From: dfn707@gmail.com on behalf of [Doug Nissen](#)
To: [Sadowsky, Steve](#)
Cc: [clint garwood](#)
Subject: 1503 West Ave Window Question
Date: Monday, August 04, 2014 4:36:40 PM
Attachments: [1503 West Lower Level Floor Plan Existing.pdf](#)
[1503 West Lower Level Floor Plan Proposed.pdf](#)

EXIST LOWER LEVEL FLOOR PLAN

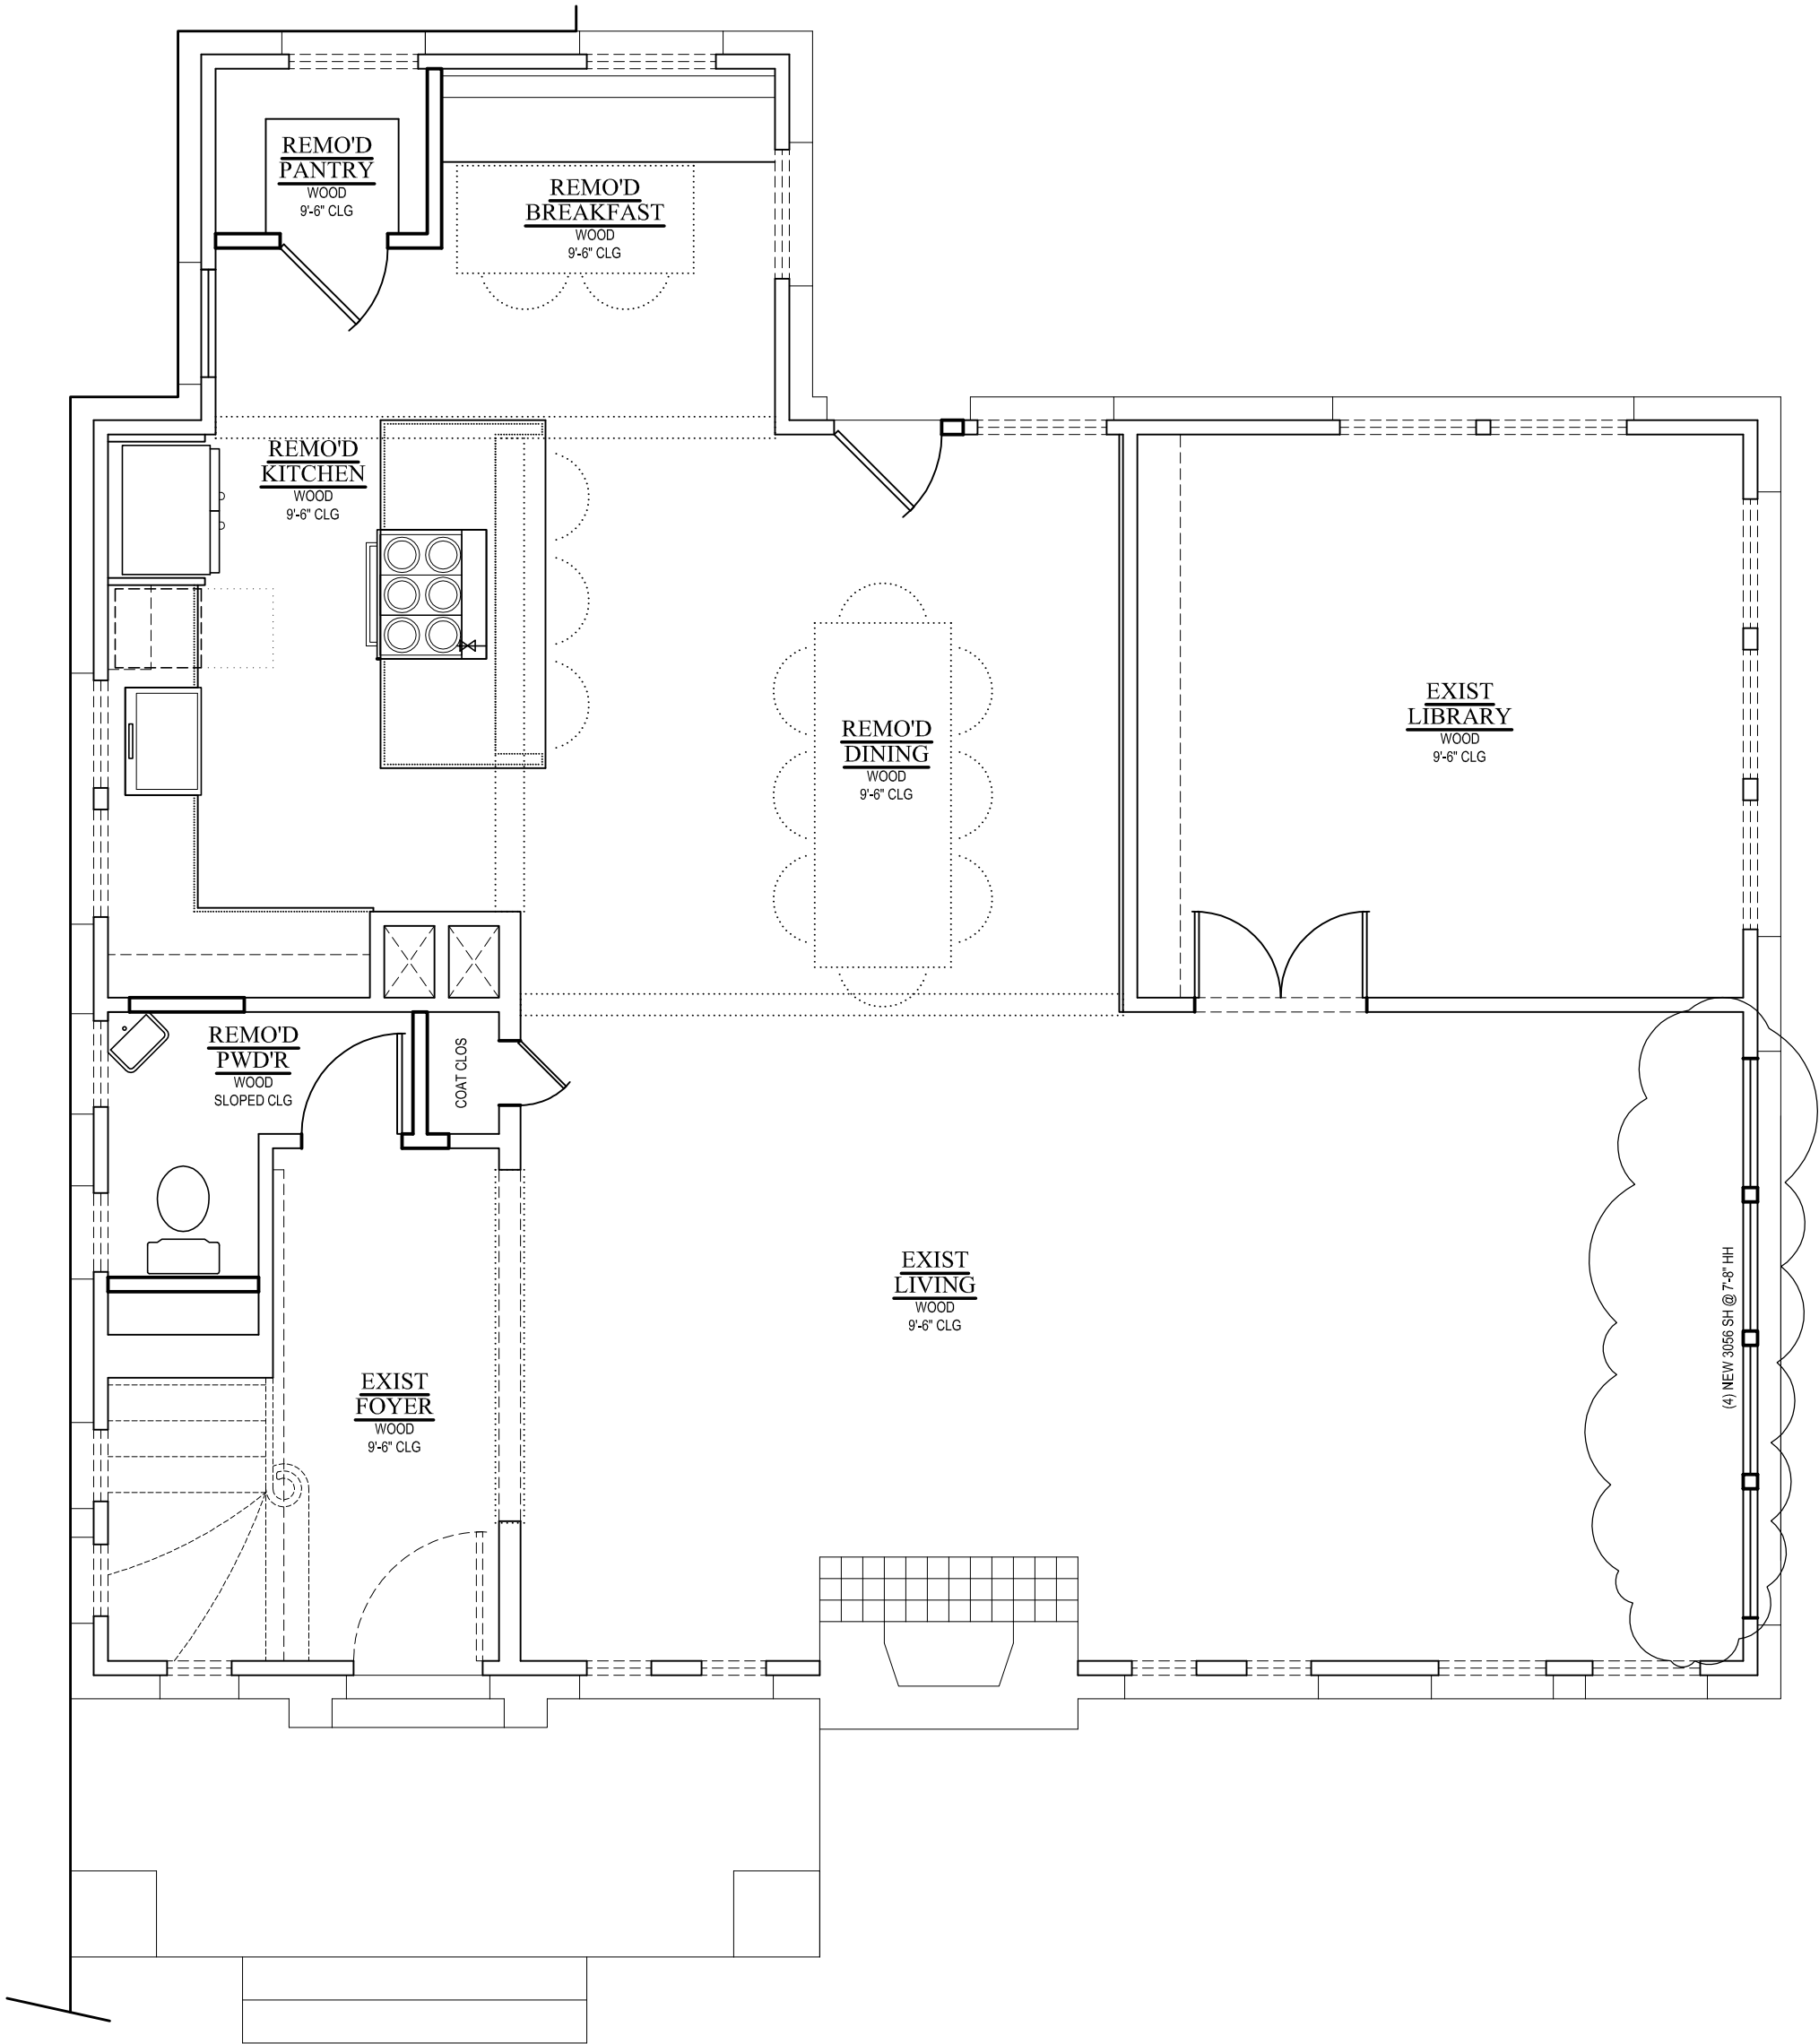
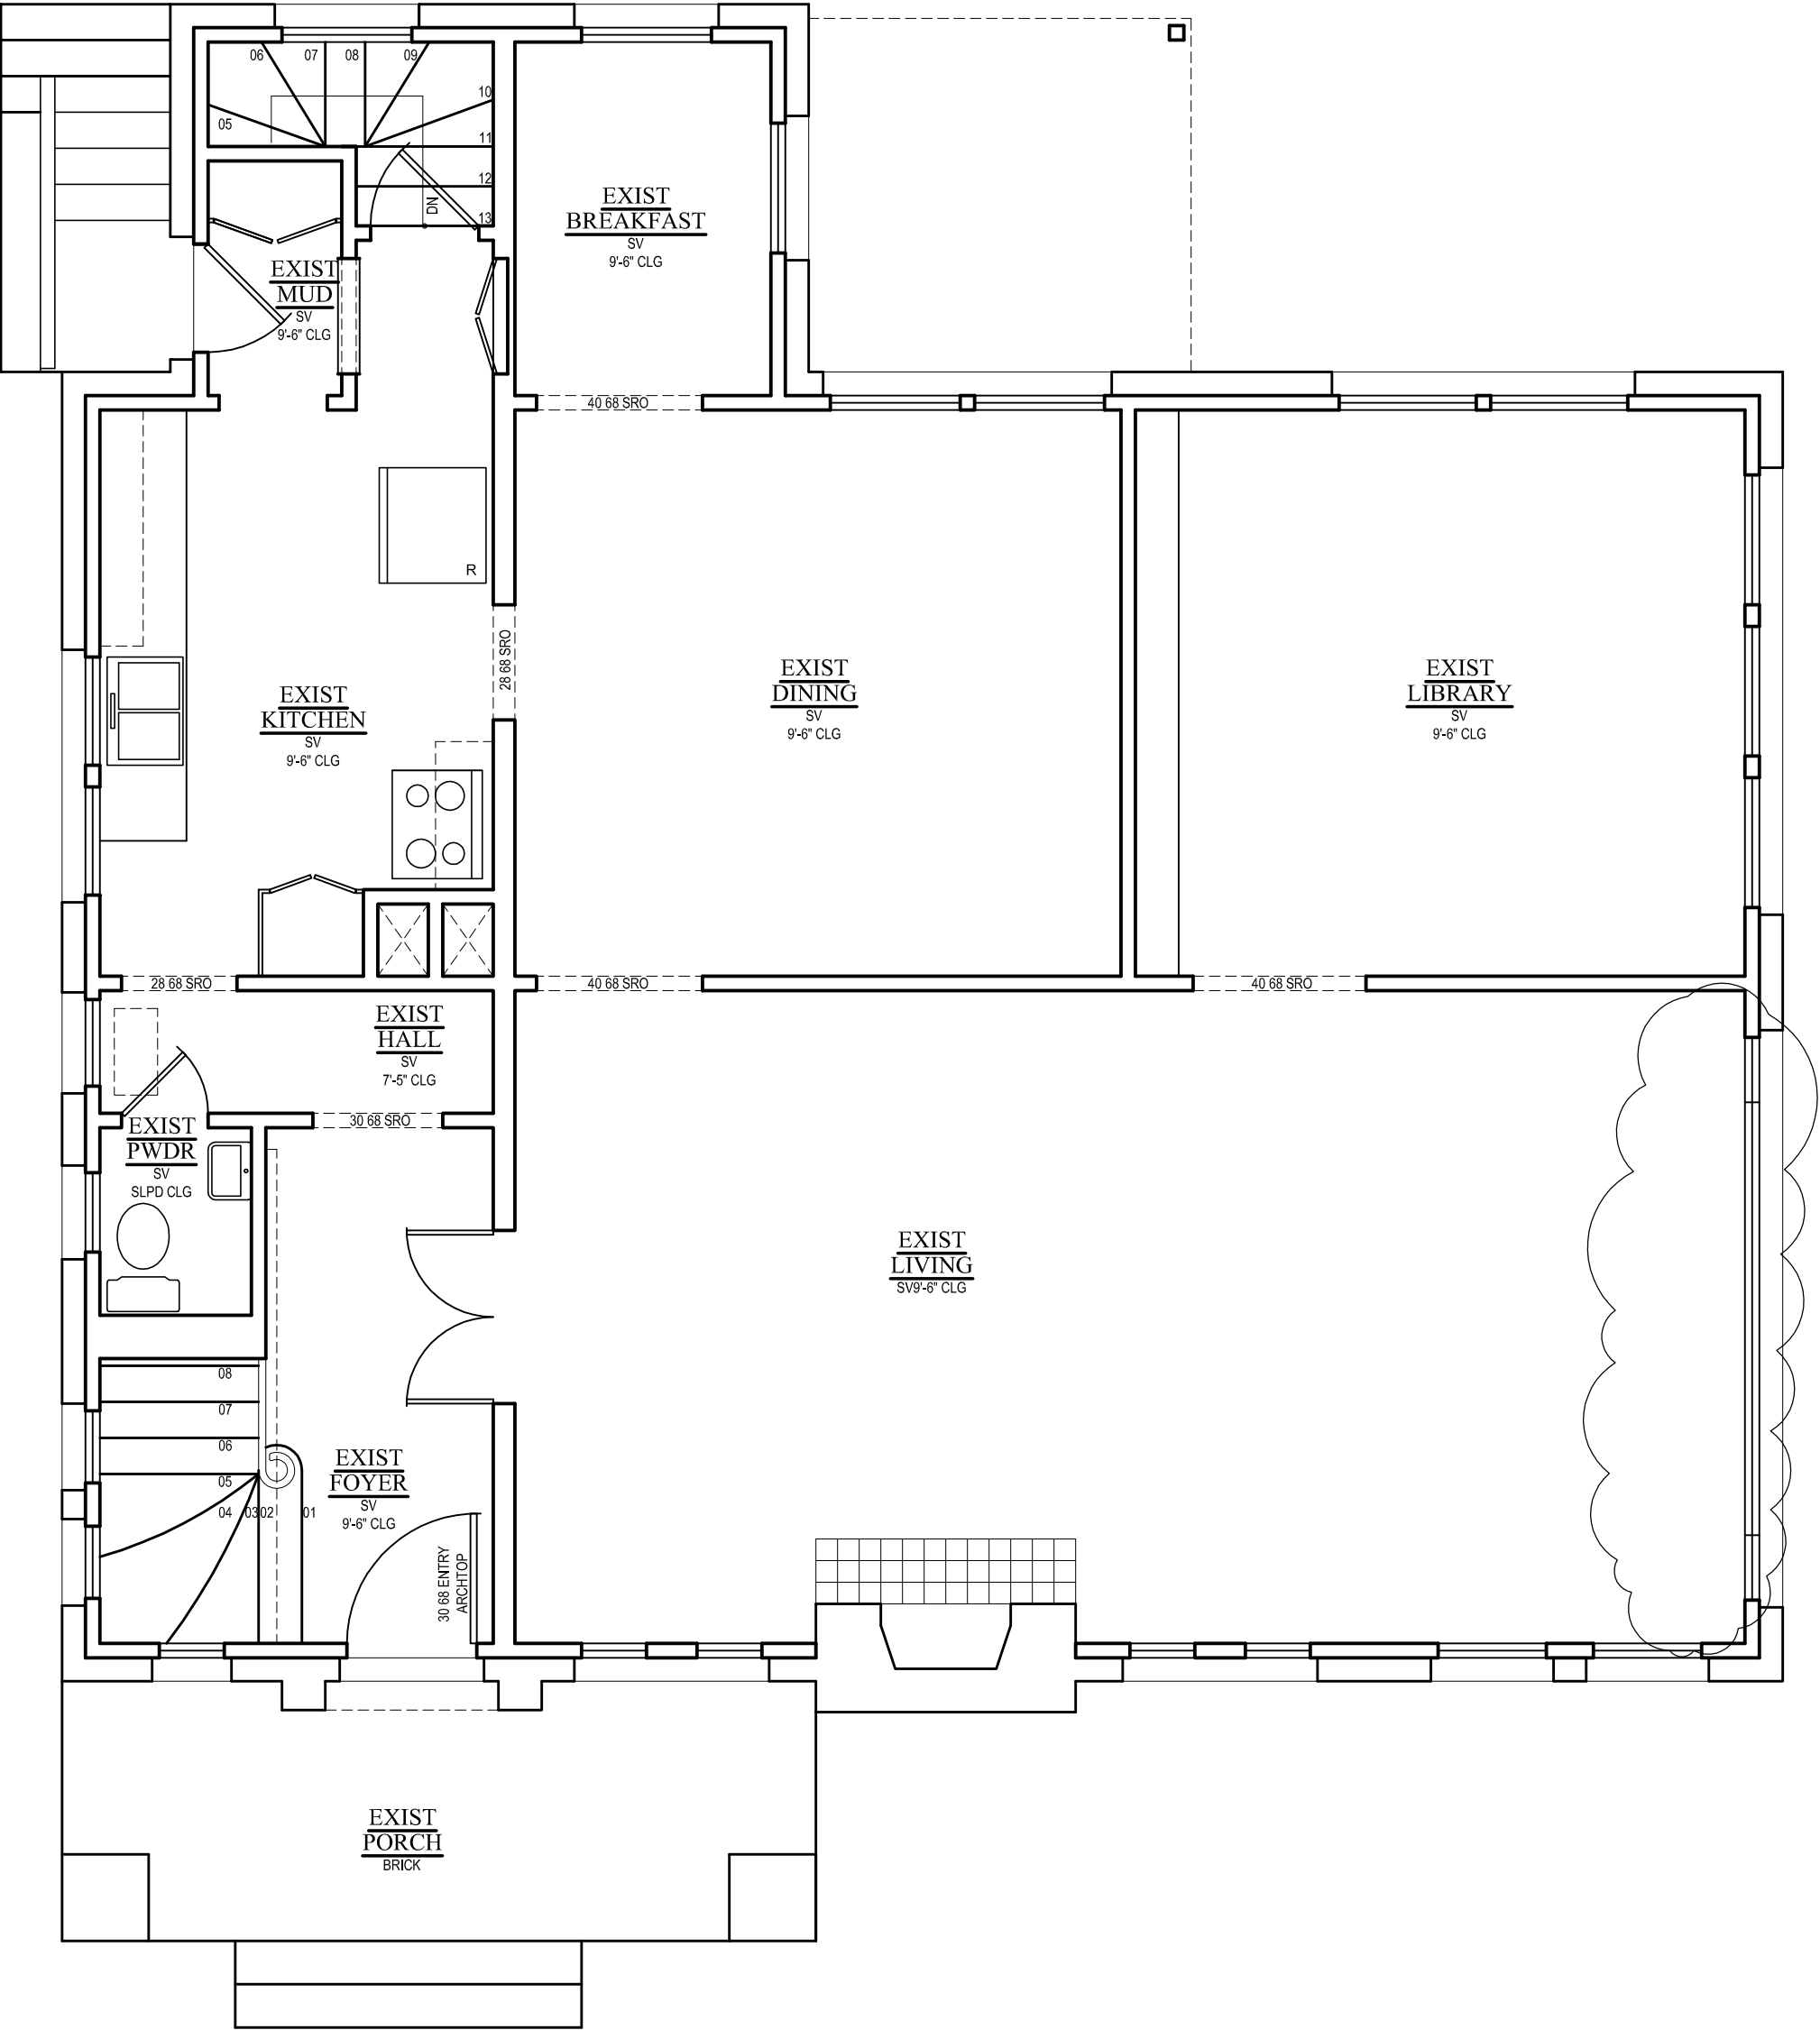
I have a question regarding the replacement of a window. Some time ago, a picture window was installed in a porch enclosure at this historic home. The window really doesn't fit with the house, so we're proposing to replace the single large window with 4 smaller ones that will match the adjacent Library windows. The overall opening width would not be affected, nor would any of the brickwork. Refer attached photos and pdfs.

So the question is, could this proposition be granted an administrative approval?
